# SERVICE BULLETIN

**Service Bulletin No.:** DAC1-74-01 Rev 0

**Title:** Ignition Harness Routing

- 1. ATA Code:** 7420
- 2. Effectivity:** All DA20-C1 Aircraft.
- 3. General:** This Service Bulletin addresses a revision of the ignition harness wiring to improve cold weather starting. The revision consists of switching the spark plug leads from the top to the bottom.

**Figure 1**  
Left Side View of Engine

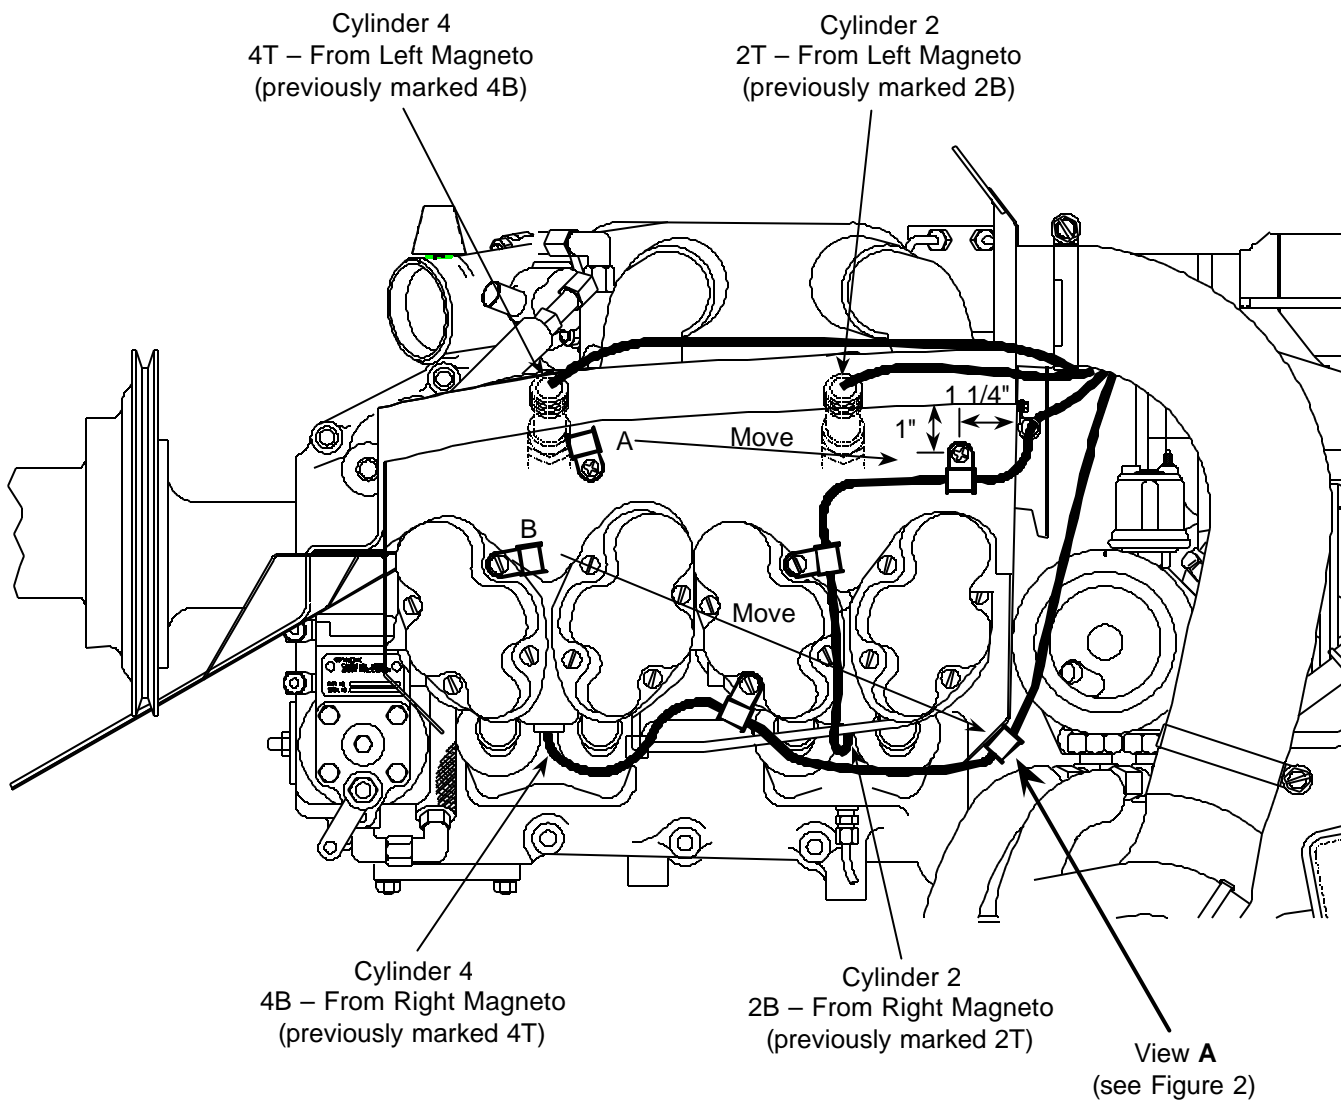
- 10. Accomplishment Instructions:**
  - 10.1** Remove the cable ties from the harness behind the engine (Note the locations).
  - 10.2** Drill a #10 diameter hole 1¼" forward and 1" down from the upper aft corner of the right baffle (Figure 1).

- 10.3** Remove the cable clamp from location A and move it to the new location (Figure 1). The hole at location A may be sealed with suitable hardware or left open (cooling air leakage is negligible).

- 10.4** Drill a #10 diameter hole 1" inboard and ½" up from lower left corner of the aft baffle (Figure 2).
  - 10.5** Remove the cable clamp from location B and move it to the new location (Figure 1). Use suitable hardware (Figure 2).

- 10.8** Reroute the harness as shown in Figure 1 and 3.
  - 10.9** Mark the ignition harness B nuts in accordance with SSI 99-4.
  - 10.10** Make a log book entry stating that this Service Bulletin has been incorporated.
